**EPA Superfund  
Explanation of Significant Differences:**

**TRACY DEFENSE DEPOT (USARMY)  
EPA ID: CA4971520834  
OU 01  
TRACY, CA  
09/27/2004**

**2004 EXPLANATION OF SIGNIFICANT DIFFERENCES TO THE  
SITEWIDE COMPREHENSIVE RECORD OF DECISION  
DDJC-TRACY**

September 2004

Figure 2-1. Soil Sites Requiring Land Use Controls, DDJC-Tracy

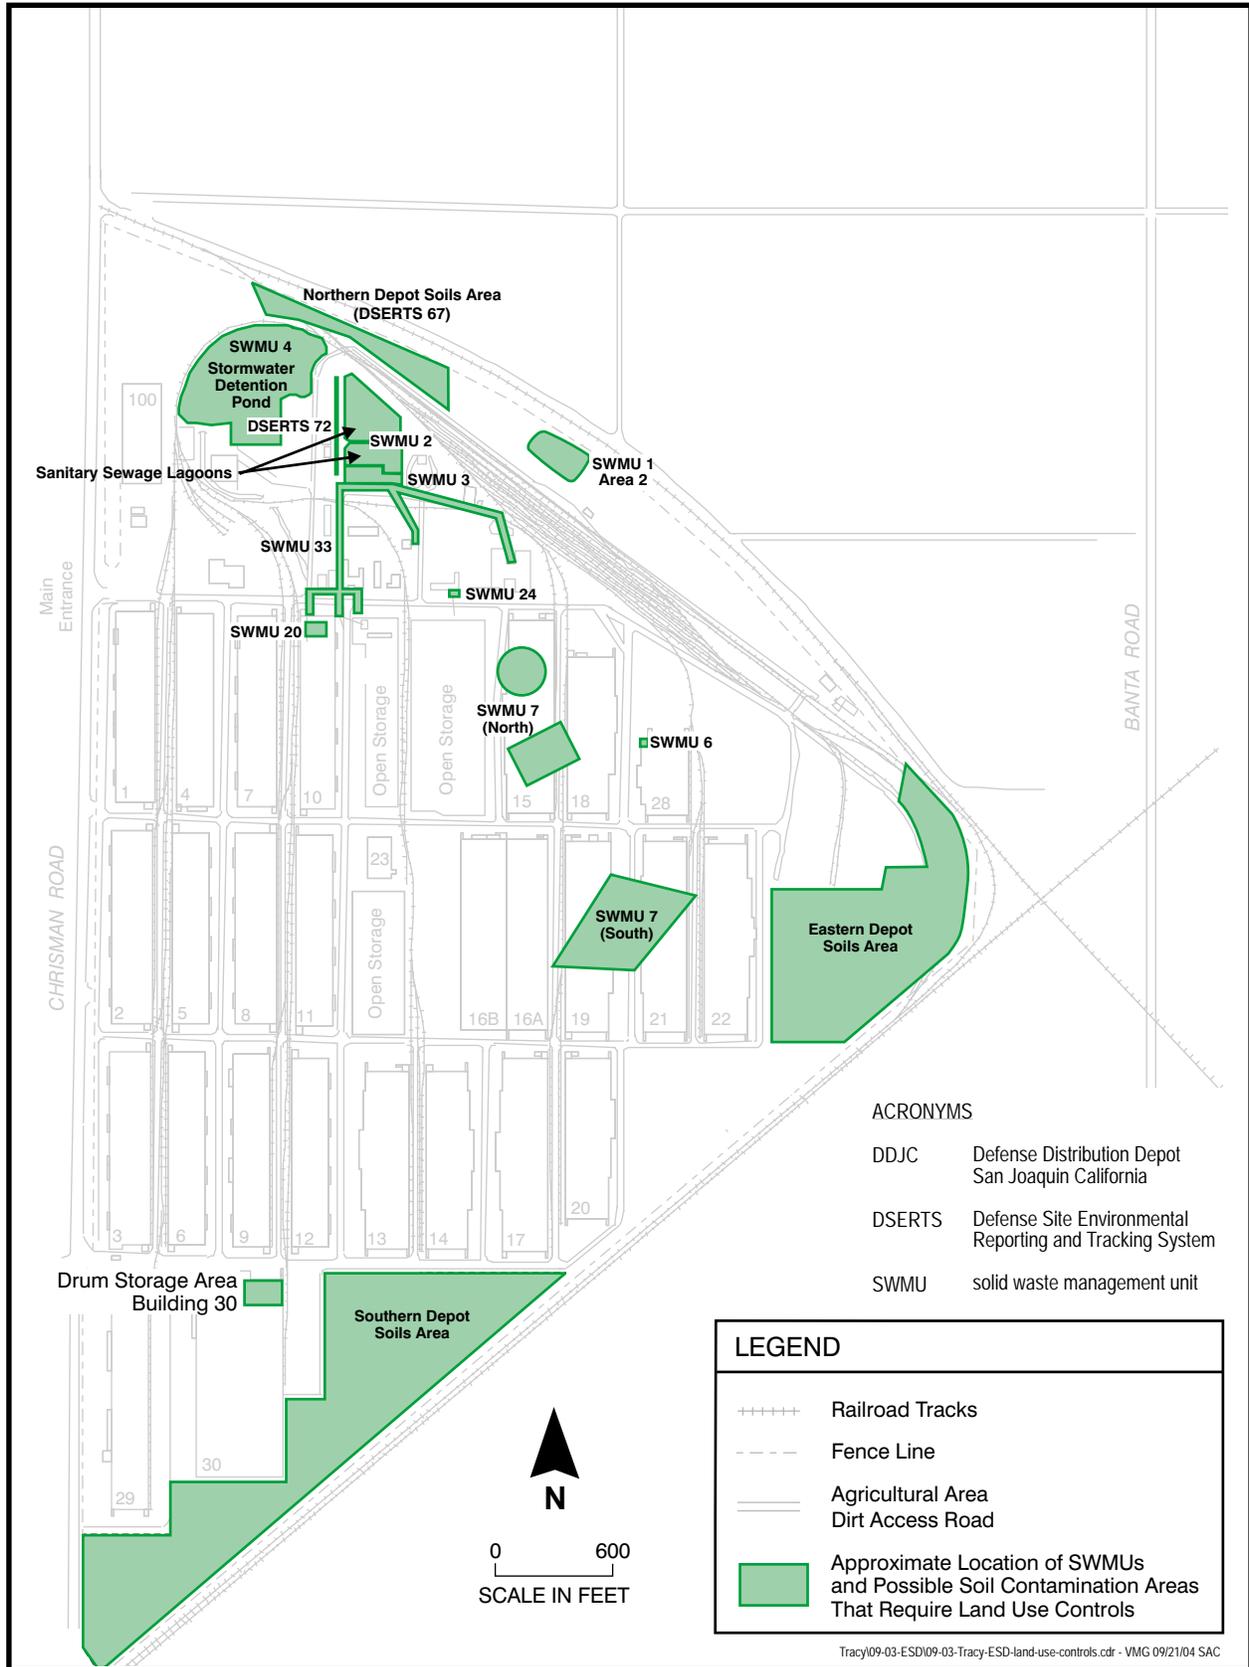
The DDJC-Tracy sites requiring land use controls are identified in Table 2-1 and shown on Figure 2-1. Figure 2-2 shows the portions of the depot and annex where groundwater use controls are required. The table provides information on the required land use controls and summarizes the environmental concerns at these sites.

Figure 3-1. Residual Soil Contamination Above ROD Cleanup Standards and DI WET Results, SWMU 6, DDJC-Tracy

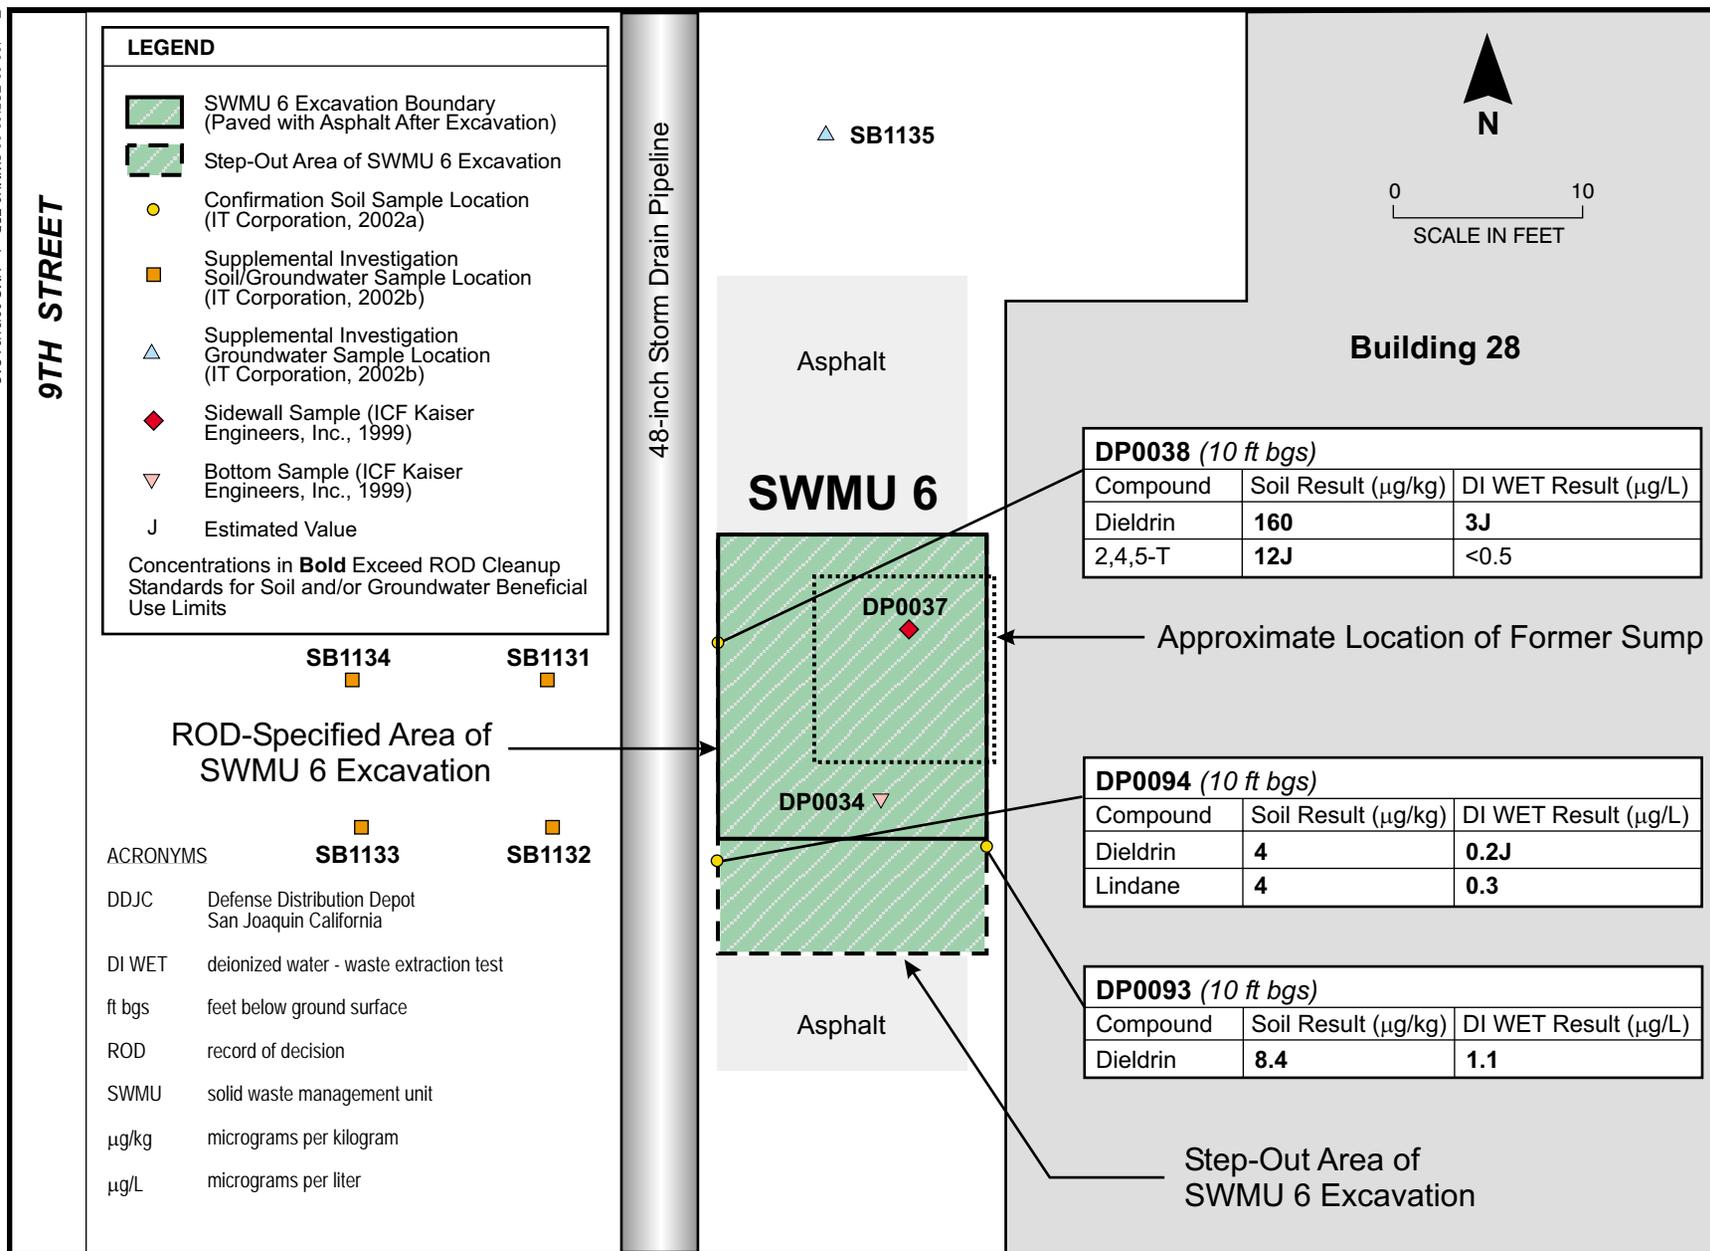
**3.1.2.4** Analytical results for the final round of confirmation sampling (step-out sampling) showed that residual contamination remains in the eastern and western sidewalls of the southern over-excavation at sample locations DP0093 and DP0094 (Figure 3-1). No additional excavation could be conducted at DP0093 or DP0094 and initial sample location DP0038 because of the proximity to Building 28 to the east and the 48-inch storm drain line to the west, respectively (IT Corporation, 2002a). Table 3-1 lists the soil sample locations at which Dieldrin, Lindane, and 2,4,5-T remain in soil at concentrations exceeding ROD cleanup standards. Table 3-2 provides the corresponding analytical results of the waste extraction test using deionized water (DI WET).

**3.2.2.2** Dieldrin, Lindane, and 2,4,5-T concentrations exceeding the ROD cleanup standards remain at the locations shown on Figure 3-1. Because 2,4,5-T was not detected in the DI WET extract, the contaminant is not likely to adversely impact groundwater. For Dieldrin and Lindane, it was appropriate to determine if the concentrations observed in soil samples are likely to migrate to groundwater at concentrations in excess of the groundwater goals specified in the ROD. To this end, a vadose zone transport modeling simulation was performed to

Figure 4-1. Residual Soil Contamination Above ROD Cleanup Standards, SWMU 8, DDJC-Tracy

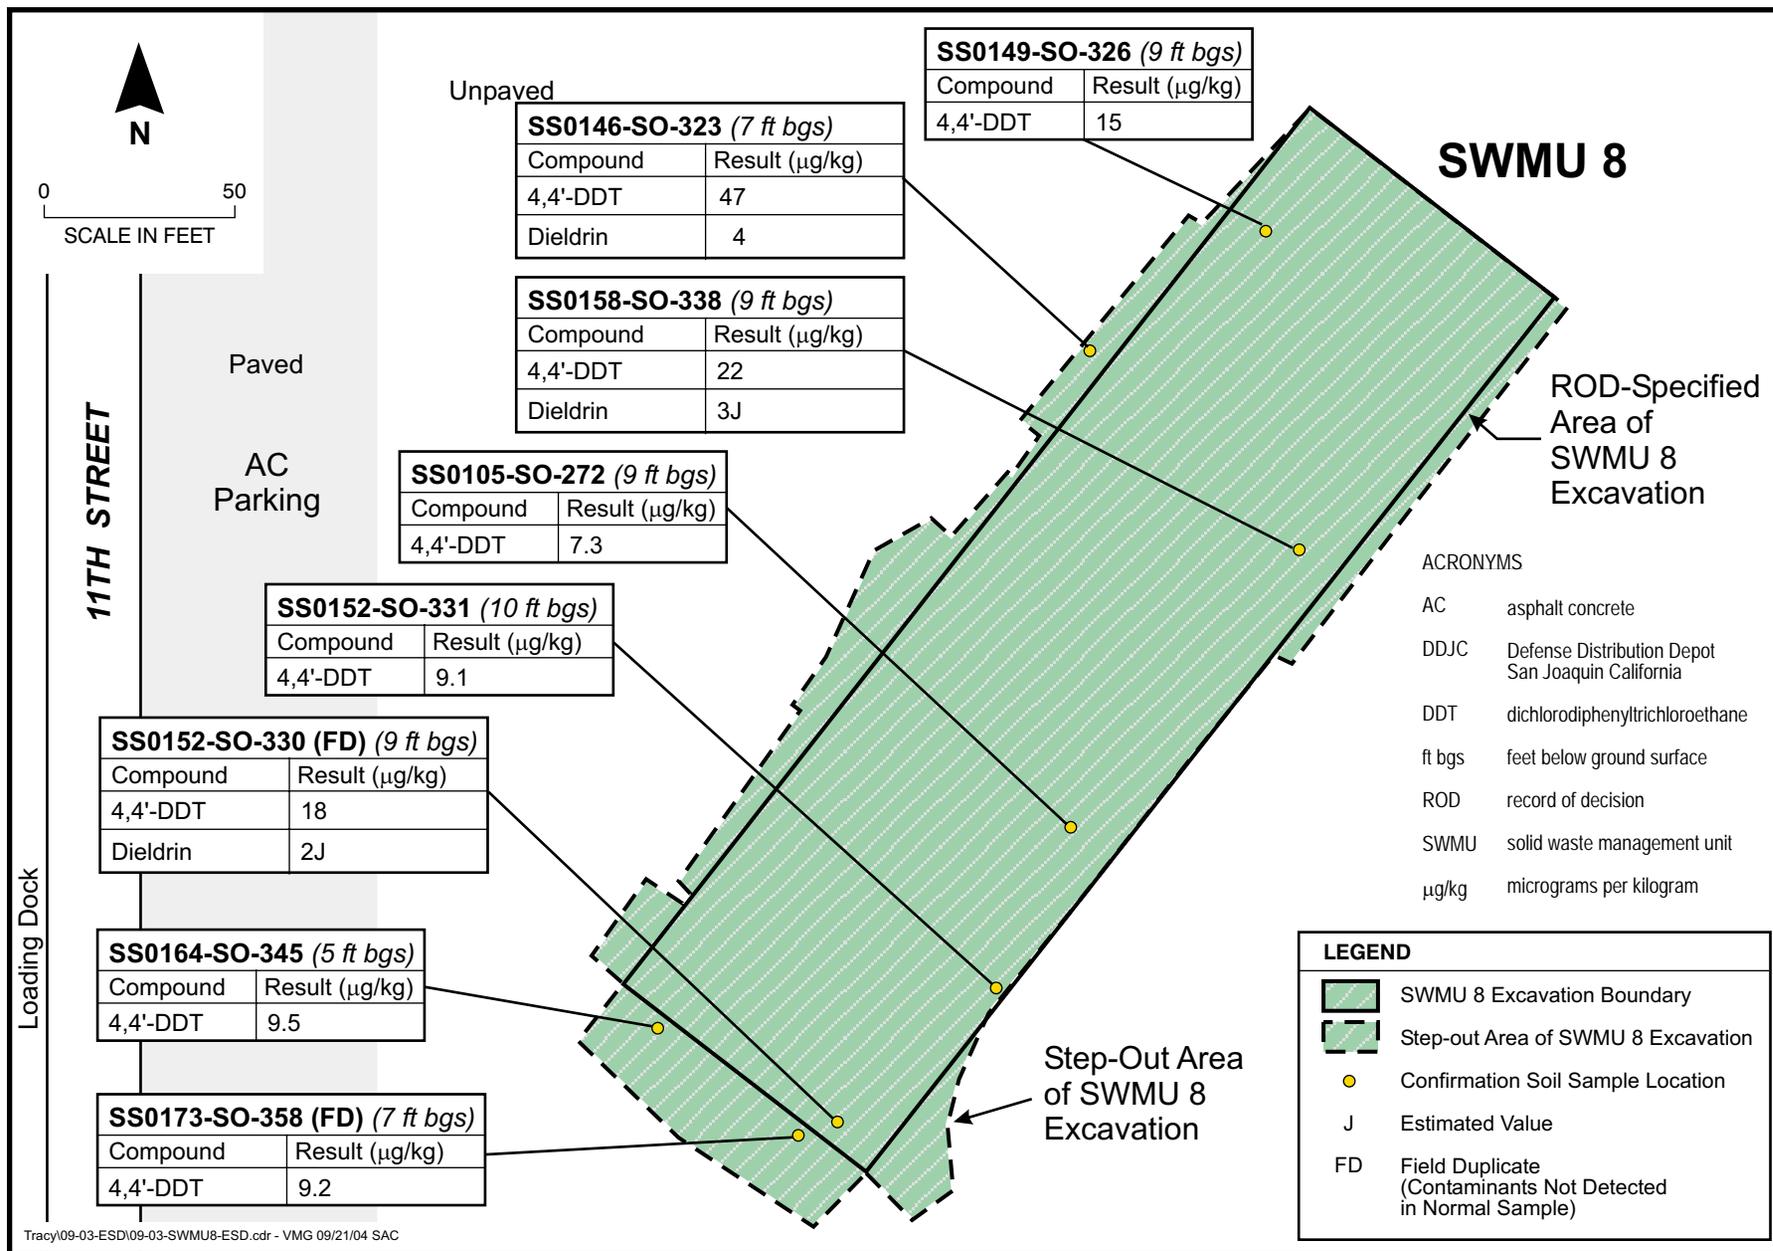
2.		Page 4-4, Section 4.2.2.2: Change "Figure 4-2" to "Figure 4-1".	(A) The figure reference will be changed as indicated.
3.		Appendix C, Residual Mass Estimates for SWMU 6: Footnote 3 indicates the hypothetical mass of residual contamination extends 10 feet north and south of the present excavation boundaries and extends to a depth of 20 feet bgs. Based on the final confirmation soil sampling, the residual contamination actually extends east below Building 28 and west beneath the 48-inch storm sewer. Therefore, the hypothetical mass should extend 10 feet east and west of the present excavation. Please explain how this hypothetical mass calculation is appropriate for SWMU 6.	(A) The residual mass estimate will be revised and a sketch will be added to Appendix C that clarifies the location of residual contamination.

**Figure 5-1. Residual Soil Contamination Above ROD Cleanup Standards and DI-WET Results, SWMU 20, DDJC-Tracy**

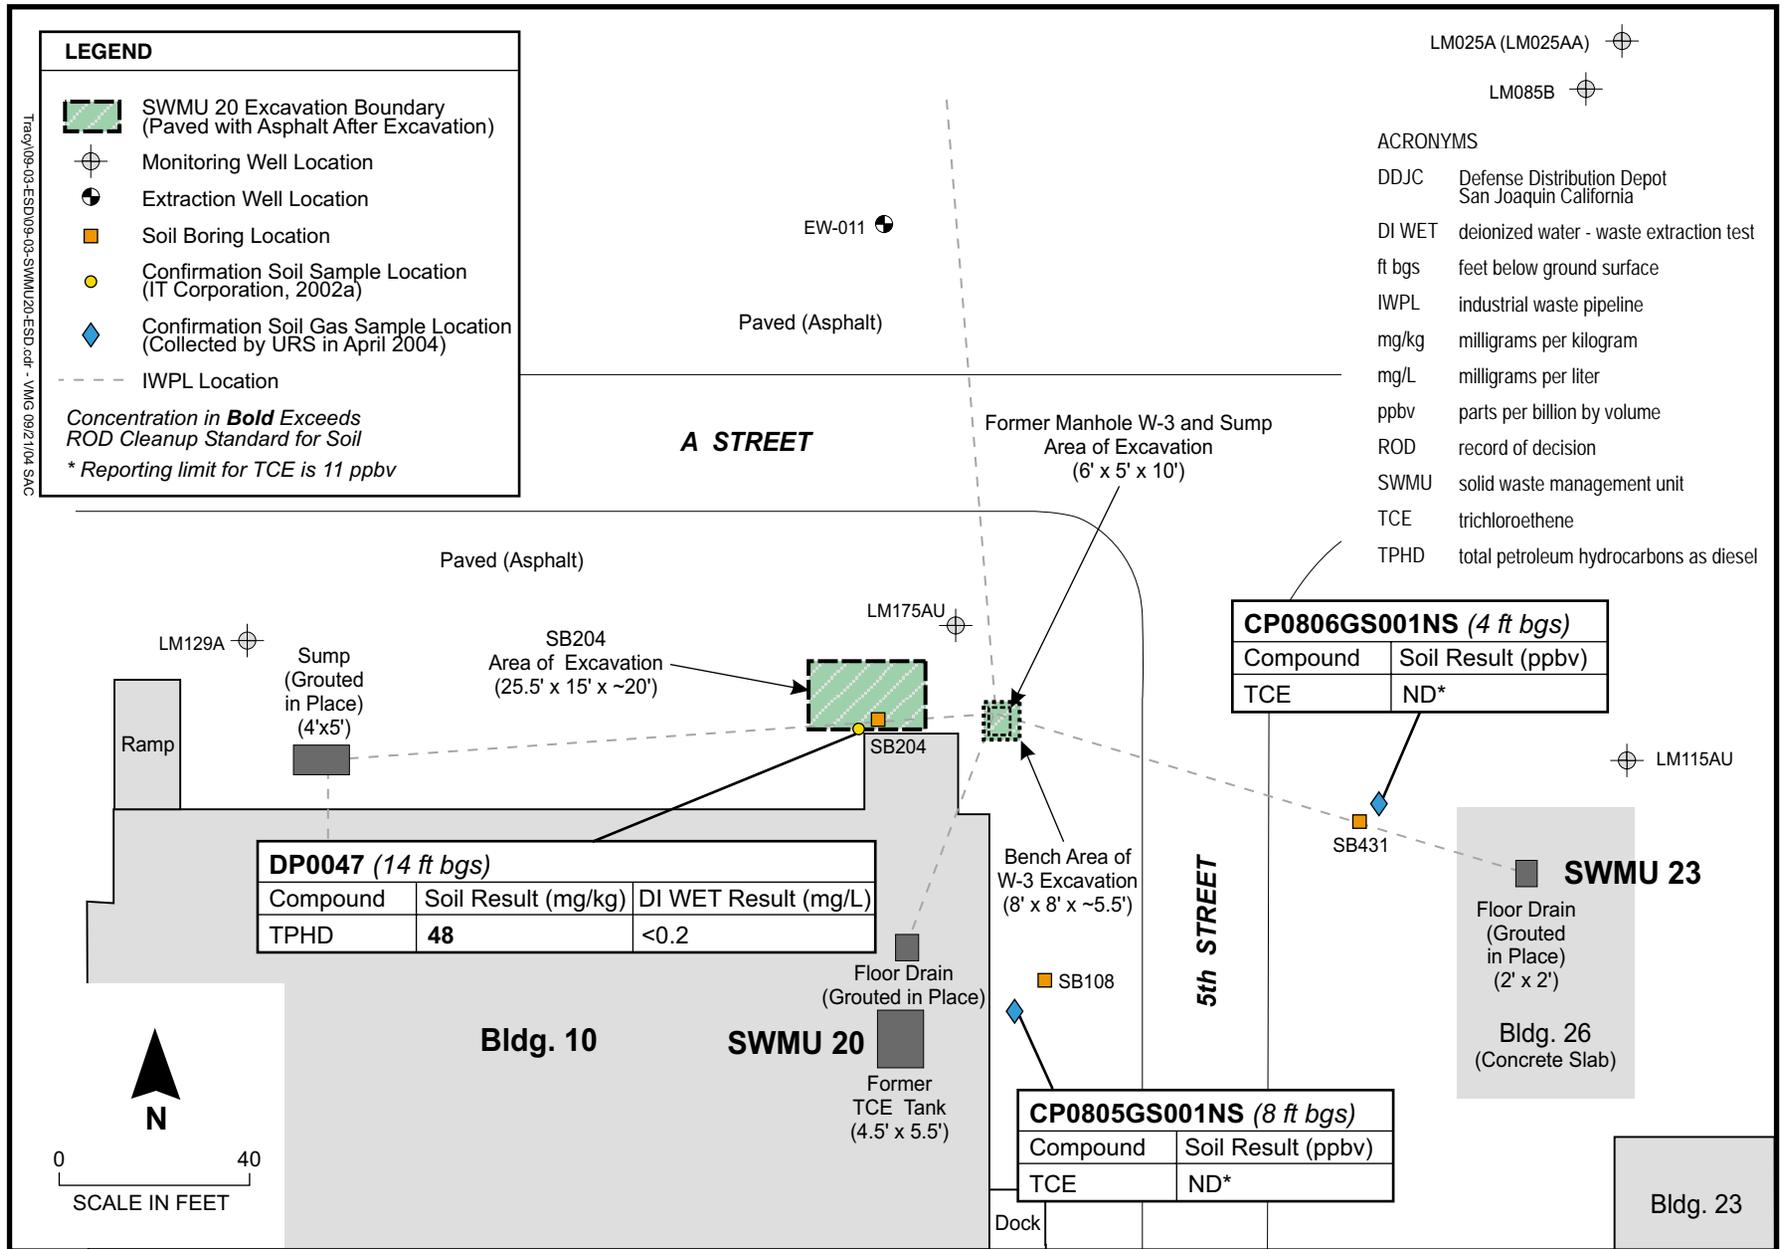
**5.3.1** This ESD adds institutional controls to the remedy for SWMU 20, consistent with the requirements in Section 2.0 of this ESD. Institutional controls are needed due to residual contamination underneath Building 10, as well as potential contamination to the east of Building 10. Because of the unanticipated extent of residual TPH contamination discovered during excavation, SVE is not expected to be effective and is deleted from the remedy. The effectiveness of the remedy for SWMU 20 will instead rely on institutional controls, excavations, and grouting activities performed at SWMU 20, SWMU 33, and OU 1. The adequacy of the remedy without SVE was assessed through additional soil gas sampling between Buildings 10 and 26. The results of this sampling effort are provided in Figure 5-1.
